Title: **RMX 2450 AC Wire Routing**
 Bulletin #: RMX0004 Issue Date: November 3, 2000
 Models Affected: RMX 2450 Bulletin Revision: A
 Production Range: 01/2000–10/2000 (serial # 0100xxxxx–1000xxxxx)

This bulletin describes a procedure rerouting the AC wiring so it is not susceptible to being pinched and shorted to the chassis.

Figure 1. The amplifier before modification.

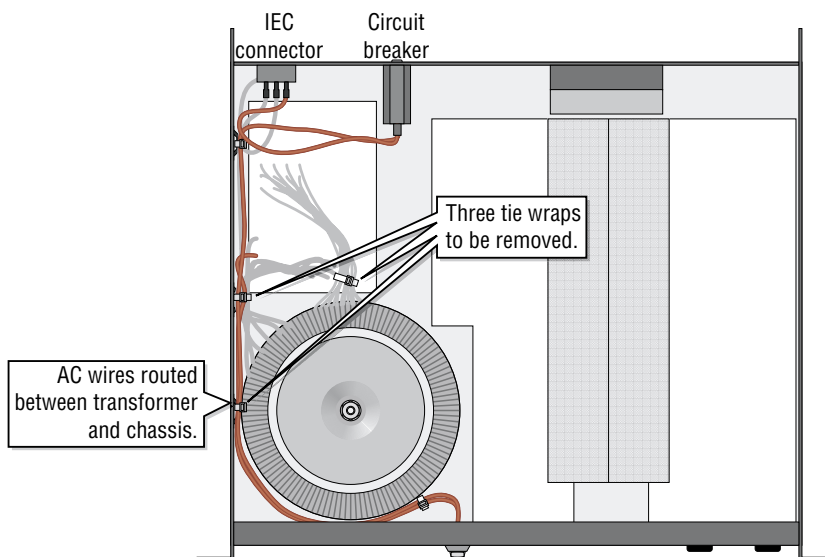
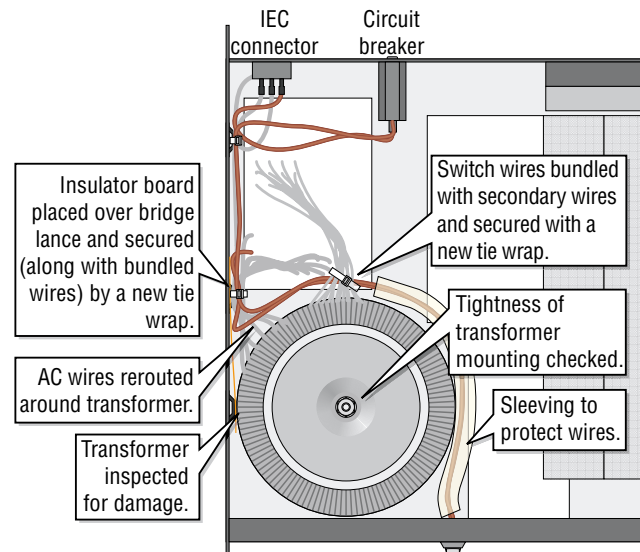
In the RMX 2450, the wiring to the AC switch is routed at the factory along the side of the chassis and secured with tie wraps to small loops (called bridge lances) in the chassis. One bridge lance lies right next to the toroidal power transformer with only a few millimeters to spare. In shipping or handling the amplifier, the potential exists for the transformer to shift and/or the chassis to flex, causing the transformer to pinch or abrade the wires against the bridge lance, and possibly cause it to cut through the insulation on the wire. This could short-circuit the AC current to the chassis, a very dangerous situation.

1. Disconnect the amplifier from AC and wait a couple minutes for internal voltages to bleed down. Remove the top cover.
2. Cut and remove the three tie wraps shown in Figure 1. Be careful not to cut into the wires or their insulation.
3. Disconnect the brown AC wires from the power switch. Lift the wires out from between the transformer and the chassis.

6. Reroute the wires around the transformer as shown in Figure 3.
7. Slide the large sleeving over the two wires and reattach the quick-connect terminals to the switch terminals.
8. Orient the insulator board with its hole up and to the rear. Slide it into the space between the transformer and the bridge lance on the side of the chassis, and between the wires and the chassis (Figure 2). Place the hole in the insulator board over the middle bridge lance.
9. Slip a tie wrap through the bridge lance; it will hold the insulator board in place. Bundle the wires with the tie wrap so they are supported, but do not tighten the tie wrap so much that it strains them.
10. Bundle the two brown wires with the secondary wires and bind them all with a tie wrap.
